# Comments on SBG Draft CRISP Report

## From John Griffiths / hfcyclists - local branch of LCC

D1 Dropped kerb entry into outside lane of Uxbridge rd opposite Caxton rd

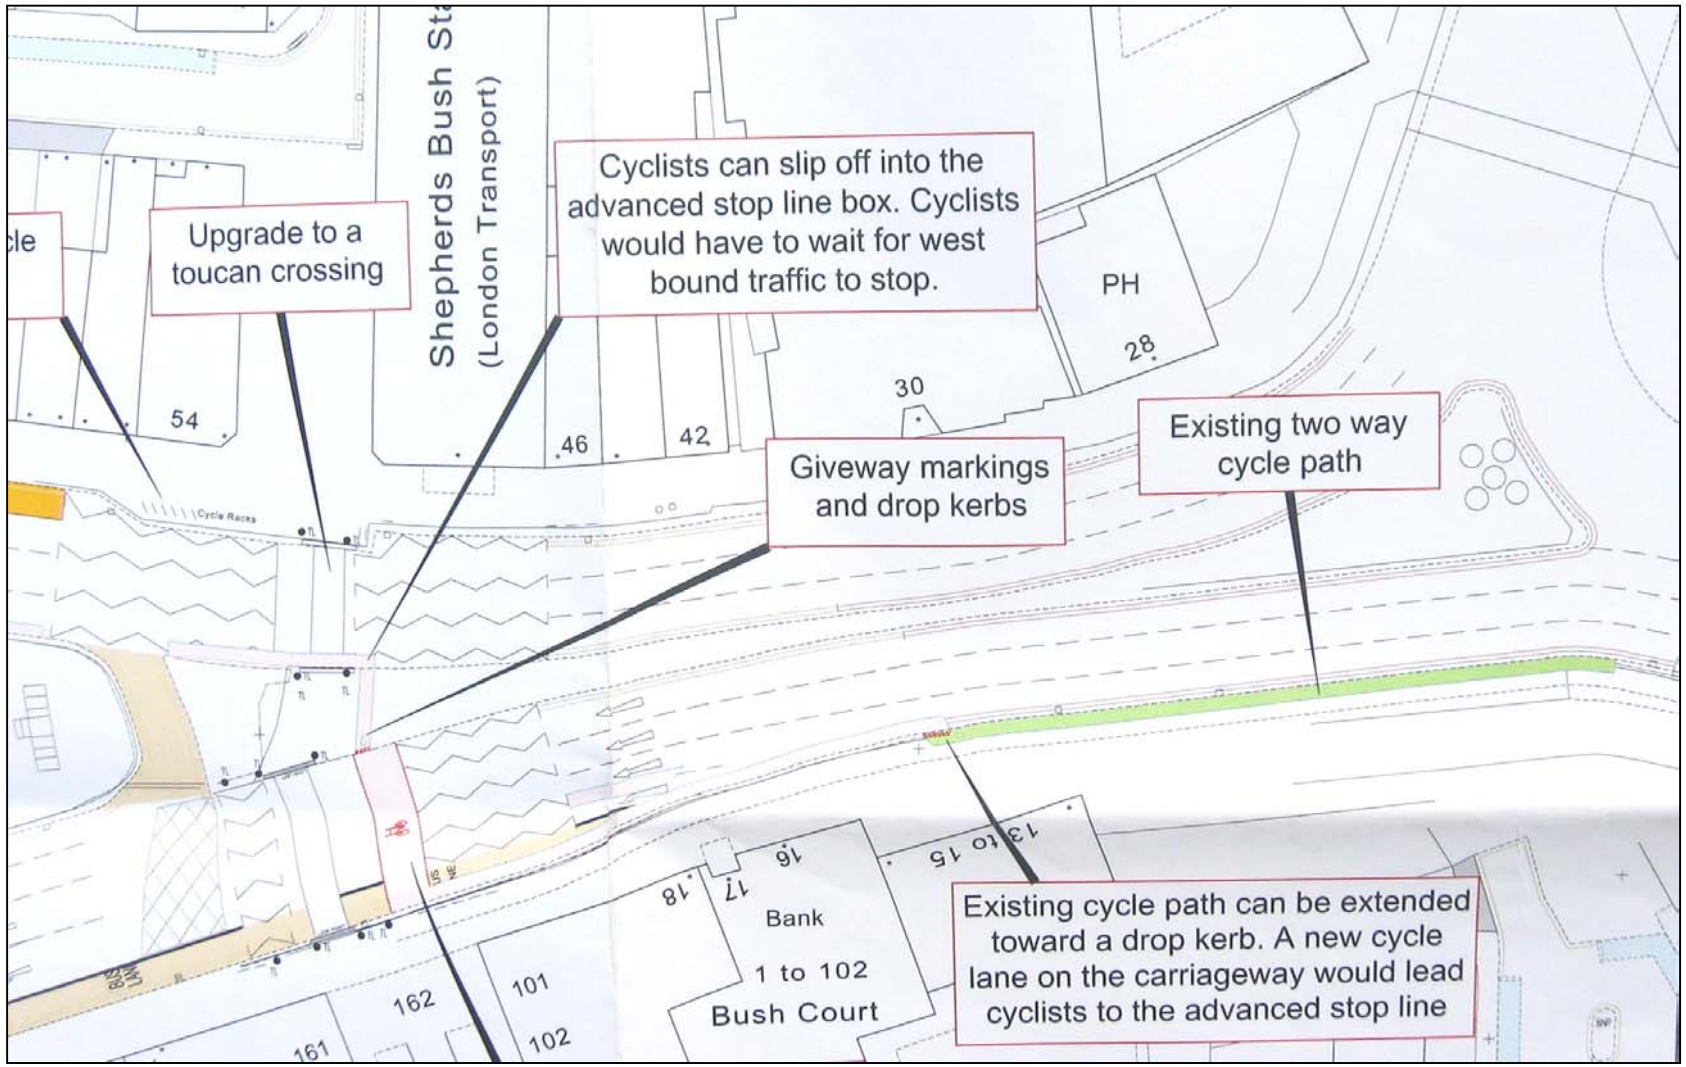
This route drops down into the outside of the fast lane of the Uxbridge rd near Caxton rd. The route leads you across the bus slip road with buses passing across your line of passage. It then assumes that you will make your way to the quadrants on the south of the roundabout via the Advanced Stop Line for westbound cyclists. This may be full of westbound cyclists.

Advisory Lane on South side of Uxbridge rd. NOT a good suggestion. Being injected into outside of fast lane RATHER DANGEROUS. And not very sensible having the lane continuing to the other side of the bus slip rd with right-turning buses turning through you.

SUGGESTION: ON UXBRIDGE ROAD. Put cycle markings regularly along the left-hand vehicle lane, indicating presence of cyclists. Make this lane wider. If any cars park in that area extend the cycle markings into the next lane too. Also good as buses pull out and cyclists may need to move over a lane.

D2 The cycle lane enters on left and continues on the far side of the bus slip road. I advocate an advanced stopping line at the roundabout

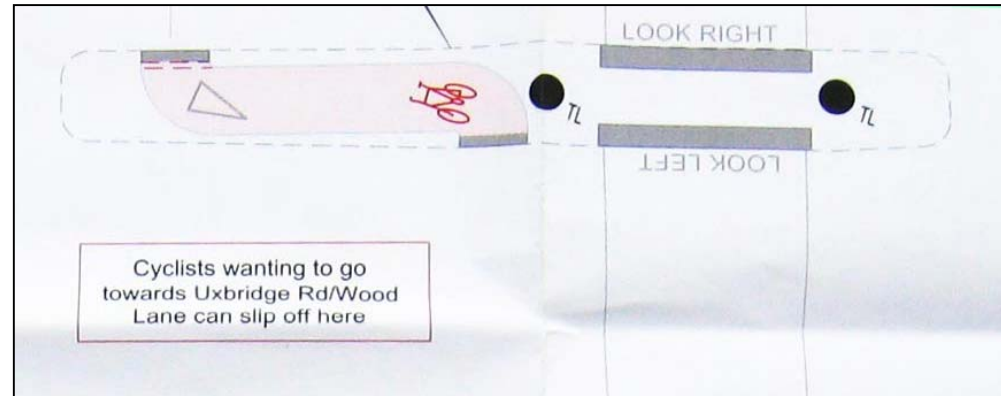
Pleased TfL have been approached concerning advancing the stopping point for cyclists at the approach to the roundabout. See 5.1.8. I hope that this gets followed through and treated very seriously. And rapidly.

- a) placing large cycle markings on 2 lanes of the roadway along the Uxbridge rd
- b) advanced stopping point at the roundabout,
- c) possibly a reservoir for eastbound cyclists next to kerb half way round roundabout. This can be taken from kerbside rather than roadway.

D3 The suggested refuge for the Rockley rd junction

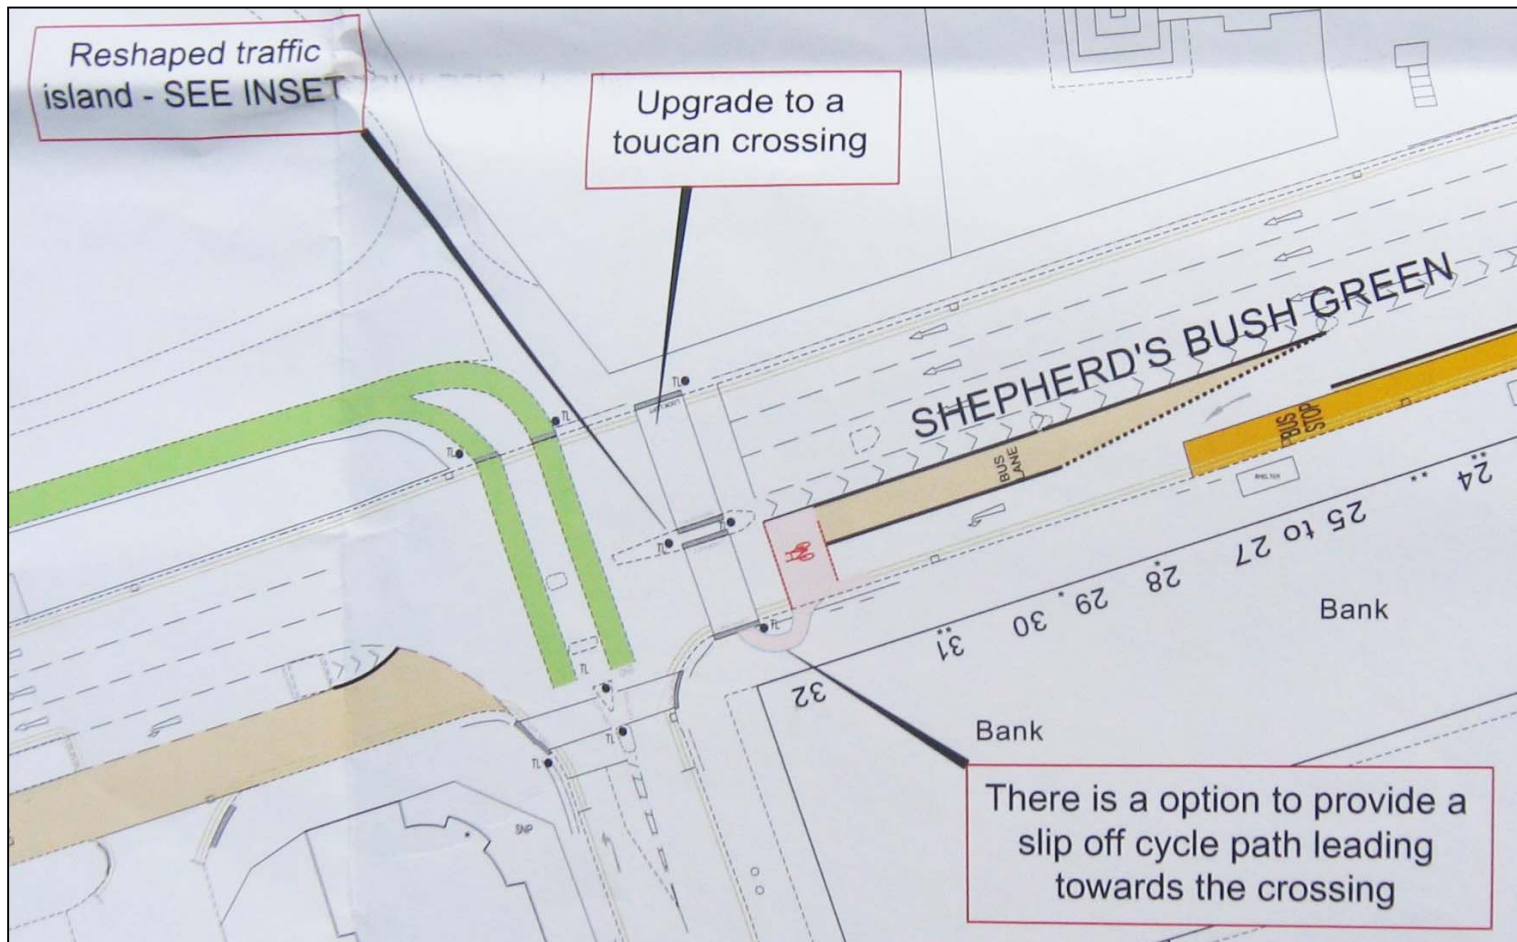
The west bound route appears to come off the quadrant, then follow the road to the Rockley rd junction, where the suggestion of a refuge to help cross to the common is good. Some details could be improved, especially the sharp turns required.

The refuge needs to be able to cater for present and future foreseeable use. You need to know expected flows per light change. You have not measured the present figure.

The proposal for a loop on pavement. Probably this will interfere with pedestrian space. No point in it being a toucan crossing, if no cyclists on pavements at either side. A refuge would be preferable.

D4 Layout of the Rockley rd junction [not present configuration of bus lane / crossing]

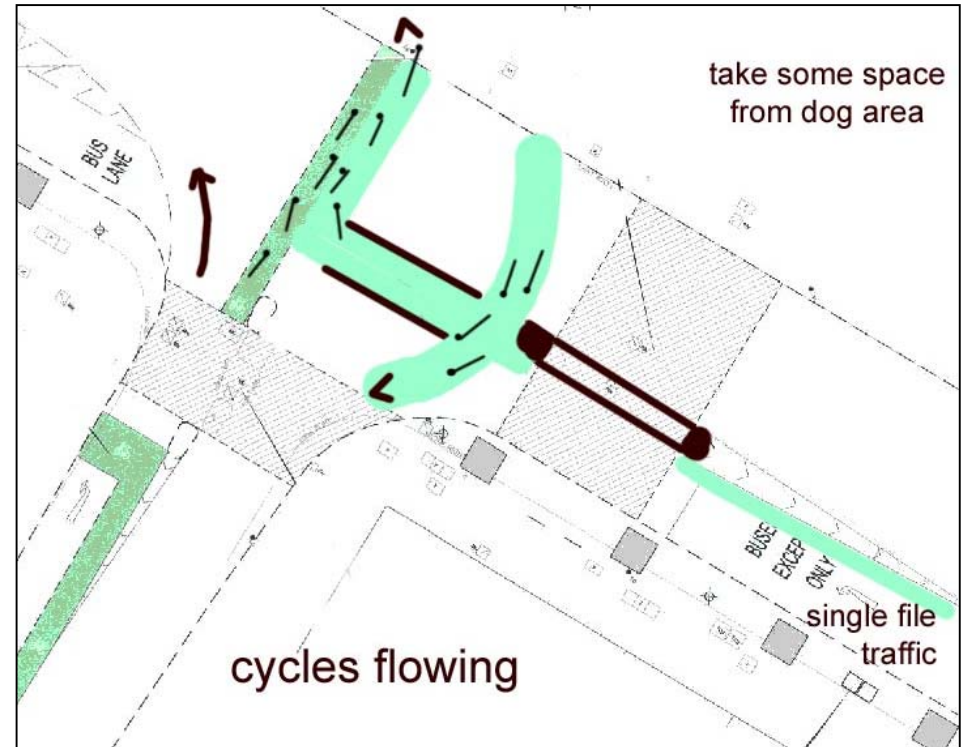
d) the correct layout of bus lane/ turn lane into Rockley rd.

D5 Suggestion for refuge at Rockley rd

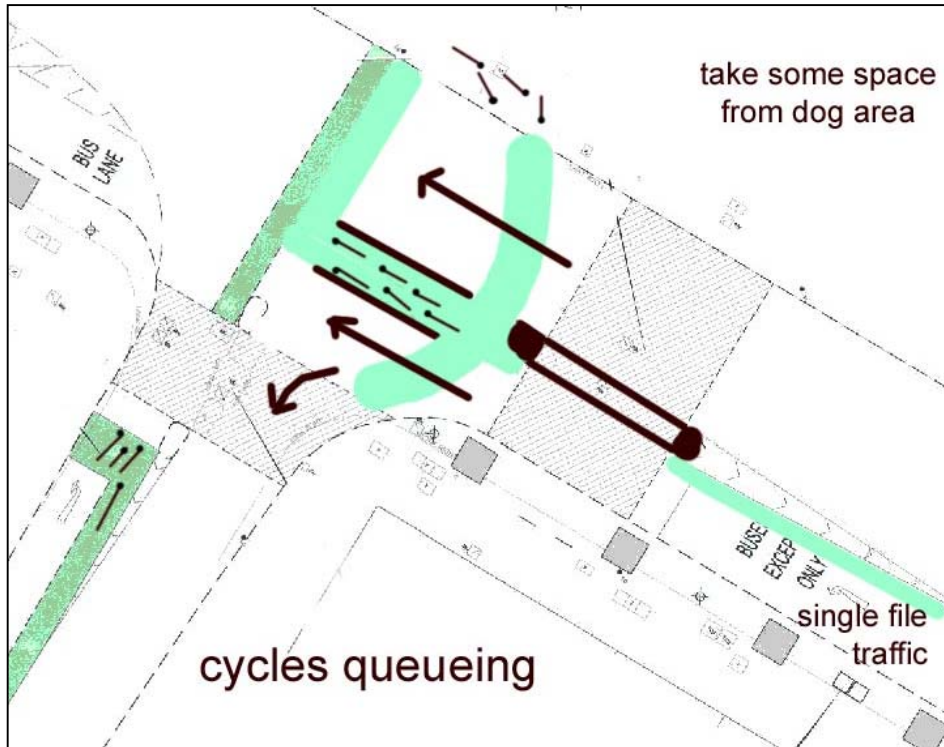
SUGGESTION I have supplied an alternative design as to how a refuge could be constructed

This design for a refuge shown at in the accompanying drawings. It has the advantage of catering for many cyclists, and delivers the cyclists to join the northbound flow from Rockley rd. It also has an easier entry, and does not require a cyclist to manoeuvre an S-bend with small radii when entering from the general traffic flow.
